## **AUGUSTA SUBDIVISION, UNIT SEVEN**

APPLICATION NUMBER 6 DATE May 3, 2007

REQUEST Subdivision

# DETAIL SITE PLAN

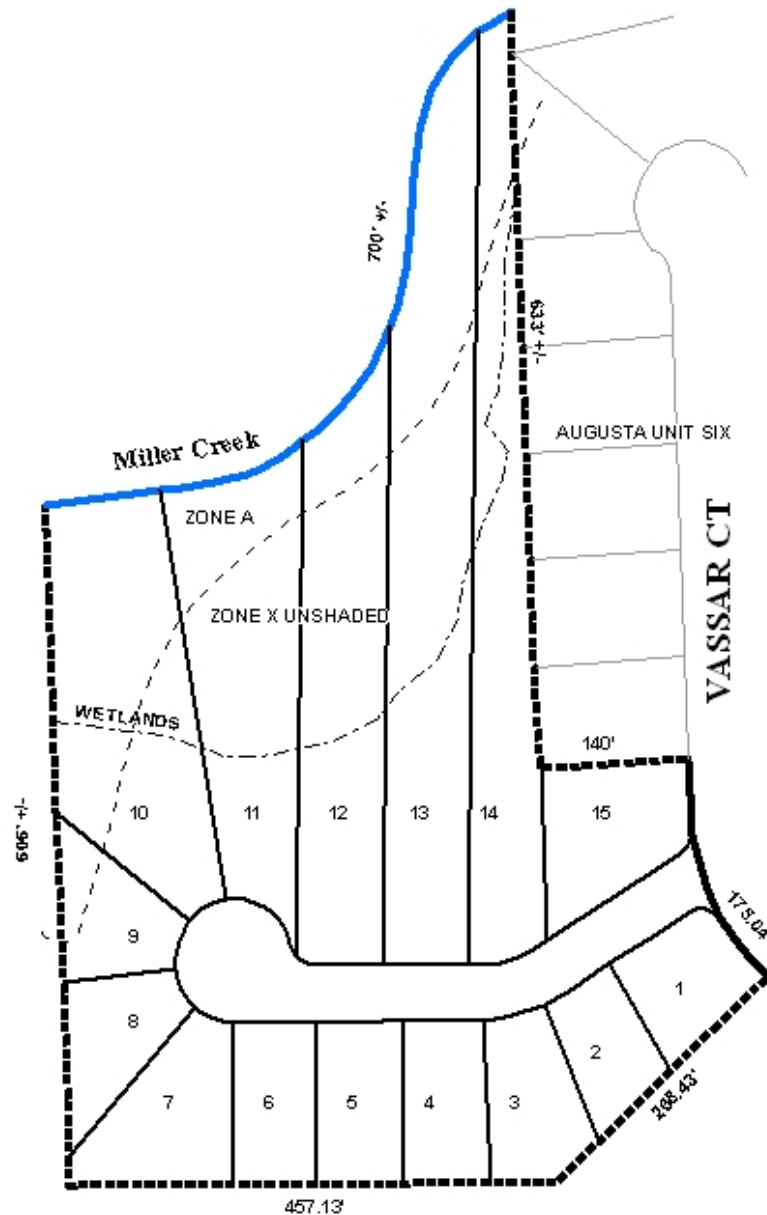
As illustrated on the preliminary plat, a cul-de-sac is proposed from Vassar Court, an existing public road that adjoins the proposed site. The proposed subdivision will incorporate three existing lots (18, 19, & 20) of Augusta Subdivision, Unit Six to provide access to the new street.

The new road for the site is to be dedicated and constructed to meet County Engineering Standards. Additionally, since Lots 1 and 15 are corner lots, a note should be placed on the Final Plat stating that Lots 1 and 15 are limited to one curb-cut each with the size, design and located to be determined by County Engineering.

Lots 11-14 as proposed exceed the depth to width ratio recommended by Section V.D.3. of the Subdivision Regulations. It should also be pointed out that lots exceeding the recommended depth to width ratio are common along creeks, wetlands and tributaries, thus a waiver of Section V.D.3. may be appropriate.

It appears that each lot meets the minimum size requirements for developments with access to public water and sewer. Due to the size of the proposed development, it is requested that the applicant revise the preliminary plat to provide the size of each lot in square feet on the plat, either as a table or as a label for each individual lot.

The 25-foot minimum building setback lines, required in Section V.D.9., are not shown, but would be required on the final plat.

The plat contains only a portion of the overall metes and bounds parcel. Therefore, the application should be heldover to allow inclusion of the remainder of the parcel, or to allow for submission of documentation to establish included portion of the metes and bounds parcel as a lot parcel of record prior to 1984.
